Product hierarchy no. *				Part no.	SBU	Type / Description	Customer part no.
SBU	PG	PGU	Type				
02	006	016	0000001504	See list below	Power Entry Modules w. Filter	5200

Product Change Notification					PCN 5200		
owner	creation date	release date	released by	change order no	rev	page	D10-007-430
schaidro	2016-08-24	2016-12-07	blumhe	2011605	A	1 of 2

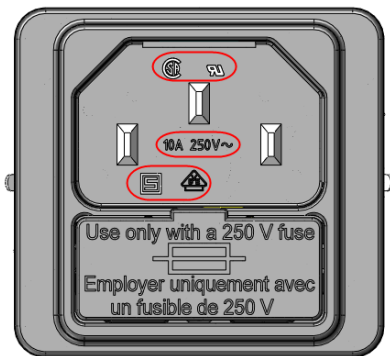
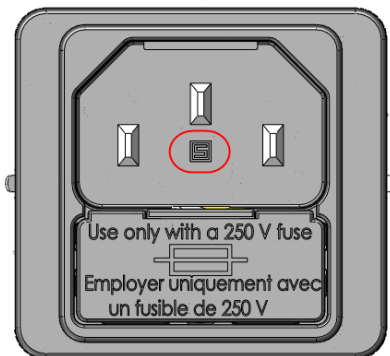
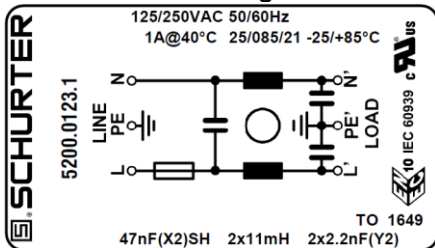
Old product appearance		New product appearance	
<div>- Slot for V-Lock cord retention</div> <div>- Fuse assembling from opposite side</div> <div>- Fusedrawer has two latches on the side to pull-out the fusedrawer, until now is only one latch</div>			
<div>Screw-on mounting; Old</div> <div>Fuse insert from top side</div> <div></div>		<div>Screw-on mounting; New</div> <div>Fuse insert from bottom side</div> <div></div>	
<div>Snap-in mounting; Old</div> <div>Fuse insert from top side</div> <div></div>		<div>Snap-in mounting; New</div> <div>Fuse insert from bottom side</div> <div></div>
